SERVICE BULLETIN

STARTING — PNEUMATIC STARTER — INTRODUCTION OF A NEW STARTER
WITH THE REMOVAL OF THE OIL SIGHT GLASS

V2500 Series 80-0025

STARTING - PNEUMATIC STARTER - SIGHT PLUG REMOVAL

FAMILY TREE — V2500-A1, A5 AND D5 PNEUMATIC STARTER CHART A, SHEET 1

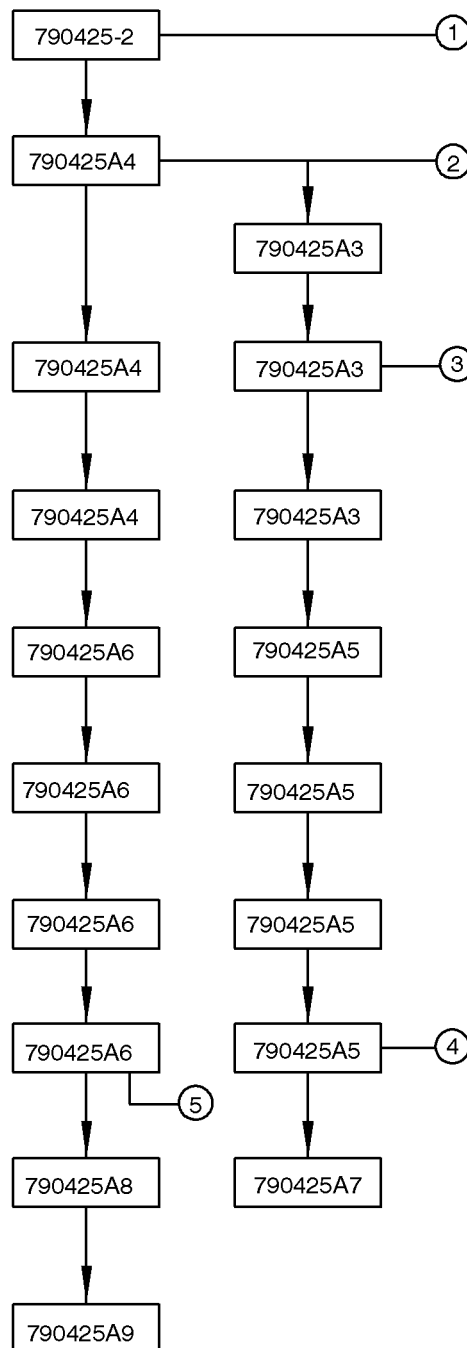
V2500-ENG-80-0025 - A1 AND A5 ONLY
INTRODUCTION OF A NEW STARTER
WITH THE REMOVAL OF THE OIL SIGHT
GLASS WHICH BECOMES INEFFECTIVE
OVER TIME

FAMILY TREE — V2500-A1 AND V2500-A5 PNEUMATIC STARTER
CHART A, SHEET 2

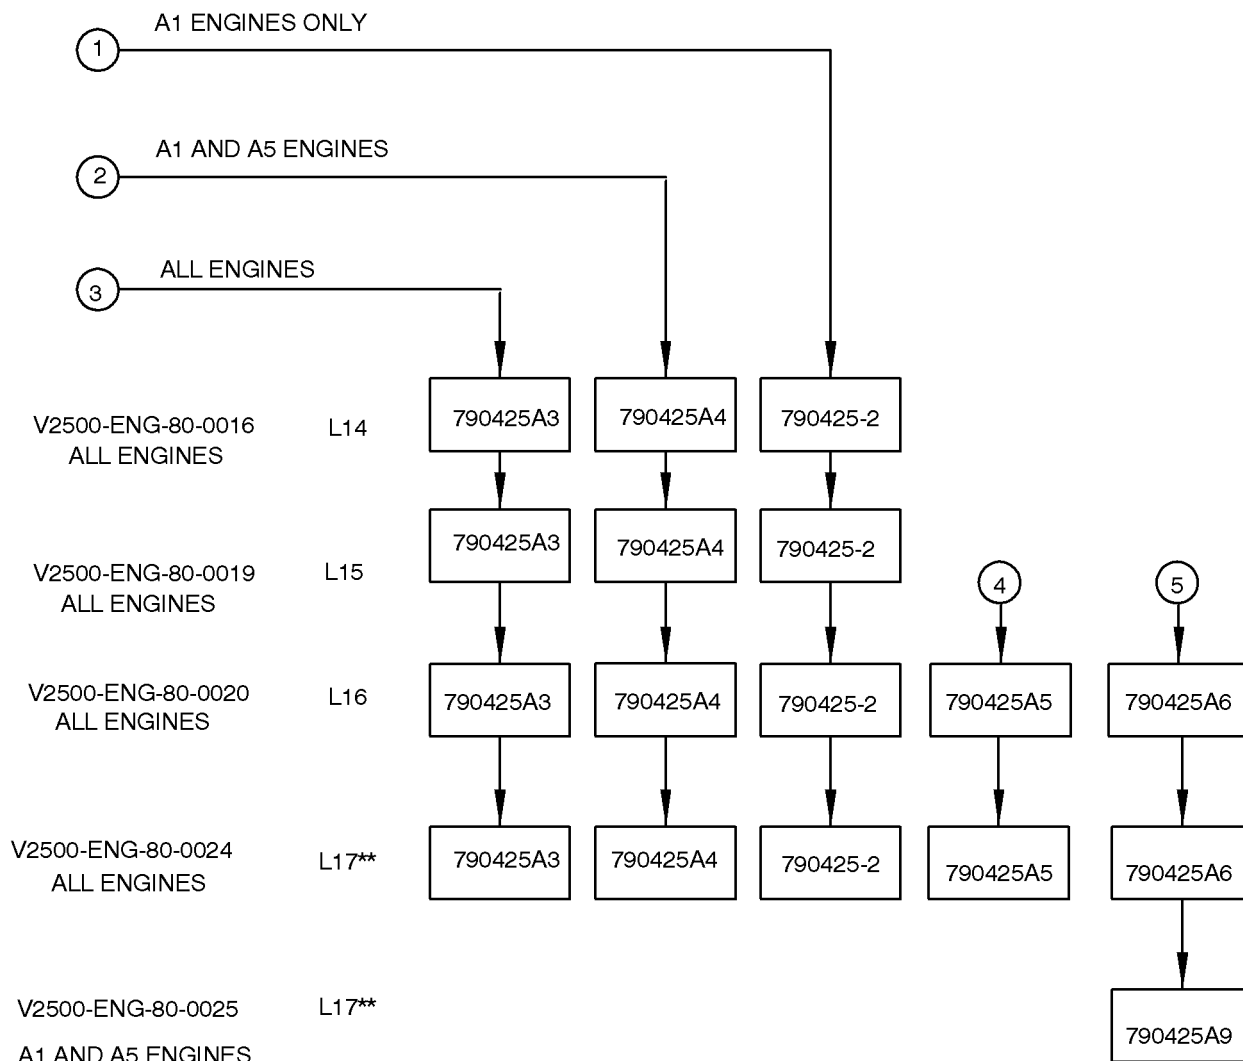
** THE L NUMBER ONLY ADVANCES TO L17 WHEN SPP SB 80-2520 IS ACCOMPLISHED
PART NUMBER IS CHANGED WHEN SPP SB 80-2521 IS ACCOMPLISHED
